**Addressing Uncertainties in “SuperBADGER” Measurements at the ZION Nuclear Power Plant (ZNPP) Spent Fuel Pool on December 5-8, 2014**

**Revision 1**

(with foreword by Eric M. Focht, U.S. NRC)

Oak Ridge National Laboratory

**Figure 1 Example of calibration data at ZNPP.**

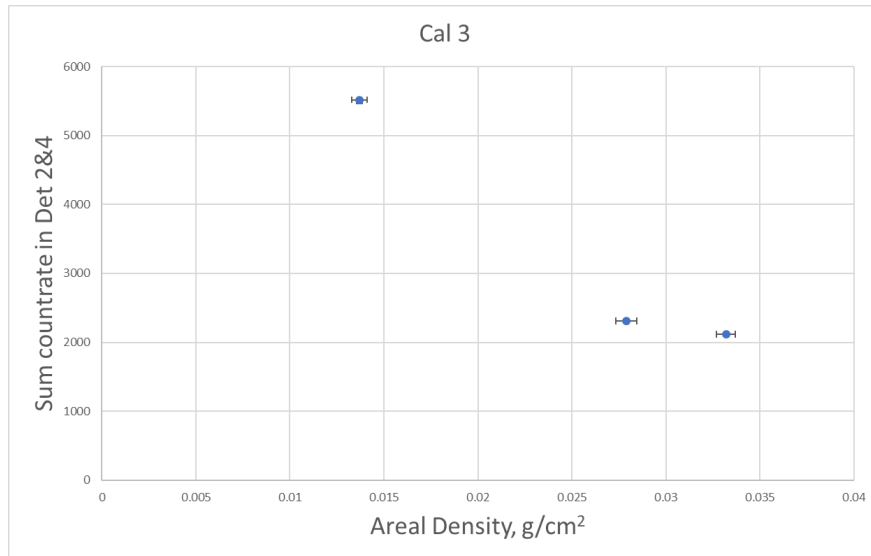
To illustrate the model bias (potential for under/over reporting of  $^{10}\text{B}$  areal density), Figure 1 shows a typical calibration shape (note this is a linear-linear plot, not transformed into ln-linear space). This is based on the 2014 measurement campaign performed at the ZNPP [2]. Only three calibration standards were used. NETCO provided raw data from the ZNPP campaign, including calibration data. For illustrative purposes, we combined the count rates from Detectors 2 and 3 for Cal 3 (Cal 3 indicates a specific set of calibration data) which was used for 18 of the Region 2 panels. The counting precision on each point is less than 1% (and are barely visible in the figure compared to the size of the plotting symbol) while the nominal uncertainty on the reference values are approximately 2.9 %, 2.0 % and 1.5 % going from lowest to highest  $^{10}\text{B}$  areal density (AD), respectively. For a given measurement panel, measured AD values varied between 0.026 and 0.030  $\text{g}/\text{cm}^2$ , thus, spanning two AD calibration zones. Values below 0.0279  $\text{g}/\text{cm}^2$  fall into the first AD-zone where the slope is steepening. The count rate corresponding to an AD value of 0.026  $\text{g}/\text{cm}^2$  in the first zone would yield a value of only 0.022  $\text{g}/\text{cm}^2$  had the calibration parameters of the second zone been used. Of course, the direction would usually be in the other direction (in this example we are extrapolating rather than interpolating). It is clear there is an argument in this case for including an additional calibration point at 0.022  $\text{g}/\text{cm}^2$ , for example, to reduce the lever arm effect. The use of five standards, where practical, would be preferred so that the spacing between points improves the quality of the interpolation. However, this is mainly a procedural matter, not an inherent instrument limitation. The choice of standards

to bracket and interpolate between should be made in relation to the data quality objectives set at the on-set, what is known about the panels to be scanned, and the local constraints. As things currently stand in Figure 1, observed rates in the first zone (roughly 2300 to 5500 counts per sec) will tend to over report the true AD value. Adding an additional calibration standard in this range will lower the reported values. This is a consequence of the non-exponential behavior of the instrument.
